**SUBJECT:** NuScale Power, LLC Response to NRC Request for Additional Information No. 285 (eRAI No. 9205) on the NuScale Design Certification Application

**REFERENCE:** U.S. Nuclear Regulatory Commission, "Request for Additional Information No. 285 (eRAI No. 9205)," dated November 22, 2017

## Response to Request for Additional Information Docket No. 52-048

### **NRC Question No.:** 15-3

Figure 1: Primary and Secondary System Interface

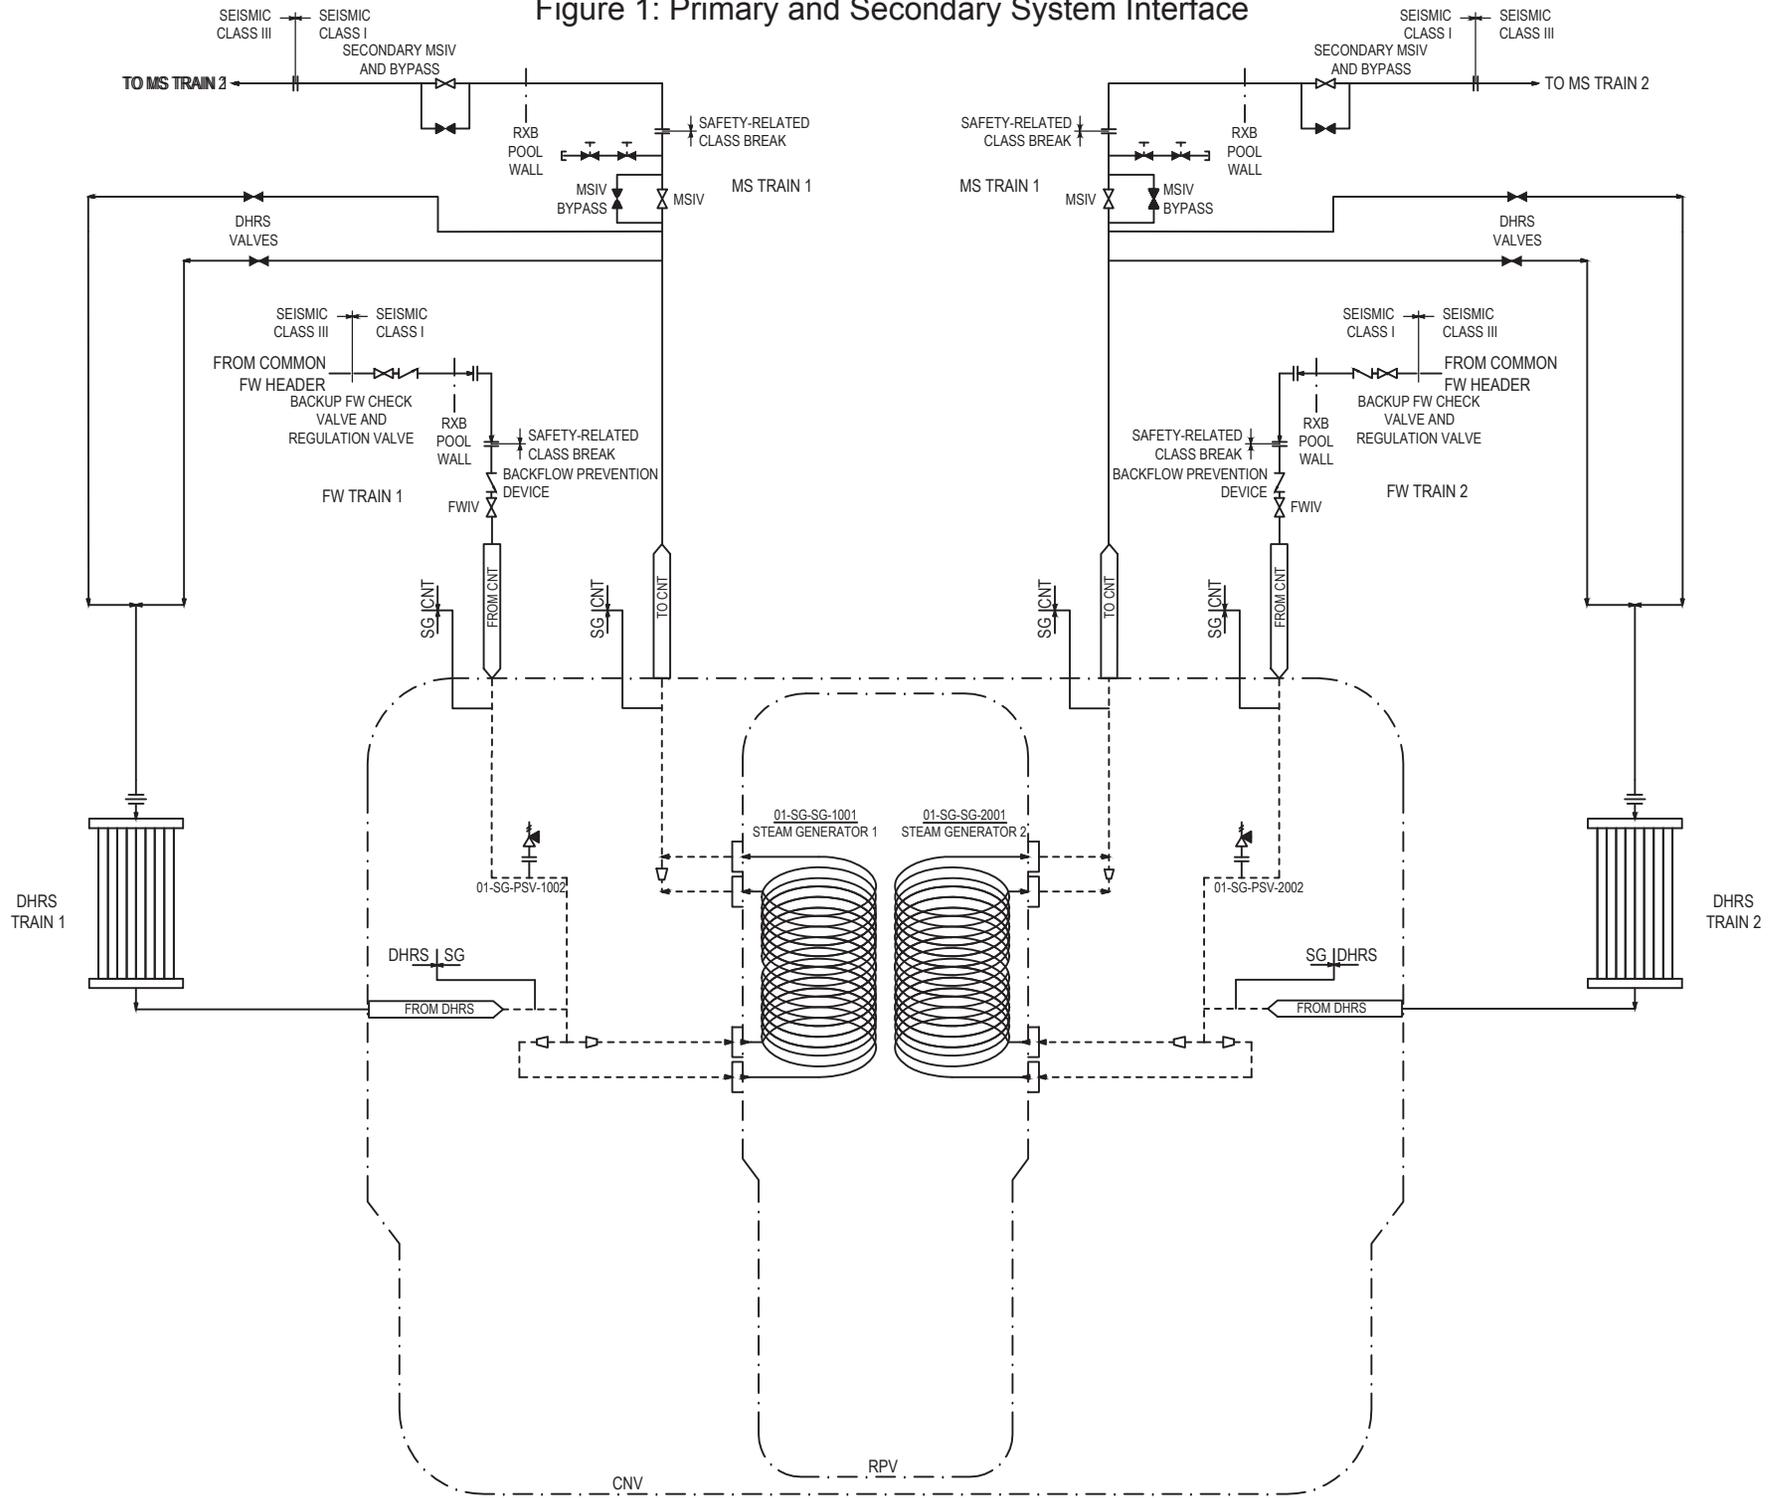
Furthermore, it is the staff's understanding that in the case of the feedwater line break inside containment, assuming no credit of the nonsafety check valve, as described in RAI 8744, Question 15.02.08-4, then there exists a potential to have both trains of DHRS inoperable which could result in core melt. The staff requests the applicant to show that for a feed line break inside containment assuming no credit of the nonsafety-related check valve, the pressure in the reactor coolant and main steam systems is maintained below 110 percent of the design values in accordance with the ASME B&PV code, and the fuel cladding integrity is maintained by demonstrating that the MDNBR remains above the 95/95 DNBR limit. If these acceptance criteria cannot be met when assuming no credit of the nonsafety-related check valve, the staff requests the applicant to provide additional information in the FSAR justifying how GDC 1 and the single failure criterion are met for this event, and clarify how the NuScale design maintains adequate defense-in-depth for its safety systems.

The limiting event for a challenge to the decay heat removal system (DHRS) operability is a large feedwater line break (FWLB) inside containment. Following a FWLB, containment pressure will increase to the containment isolation setpoint at approximately one second into the event. The safety-related check valve (backflow prevention device) in the non-faulted FW line seats at approximately one second into the event. The increased containment pressure will initiate a reactor trip and containment isolation signal and actuate DHRS approximately three seconds into the event (including sensor and signal processing time). The DHRS valves are assumed to open in 30 seconds. The FWIVs and MSIVs are designed to close within seven seconds. DHRS heat exchanger on the faulted FW line empties into containment. See Figure 1 for an integrated diagram of the systems that interface with FW system and DHRS for this event.

If the safety-related check valve in the non-faulted FW line fails to seat, the nonsafety-related check valve is credited in the non-faulted FW line to maintain DHRS inventory for approximately 7 seconds. After 7 seconds, the safety-related FWIVs on both FW lines will close, isolating the flowpath from the intact DHRS heat exchanger to the faulted FW line. Closure of either FWIV will terminate the loss of inventory from the intact DHRS heat exchanger. The intact DHRS train is only affected if the FWLB is sufficiently large to permit backflow through both FWIVs and FWRVs, with a failure of both the safety-related and nonsafety-related FW check valves. Both nonsafety-related FWRVs will also be closing on the FW isolation signal, however, these valves have a slower closing time (approximately 30 seconds) so would not be expected to isolate before the FWIVs. Closure of either FWRV would also isolate the non-faulted DHRS heat exchanger. To summarize, closure of any one of the six valves in the flowpath from the non-faulted DHRS heat exchanger to the faulted FW line would prevent draining the intact DHRS inventory. See Figure 2 for a diagram of the accident flowpath.
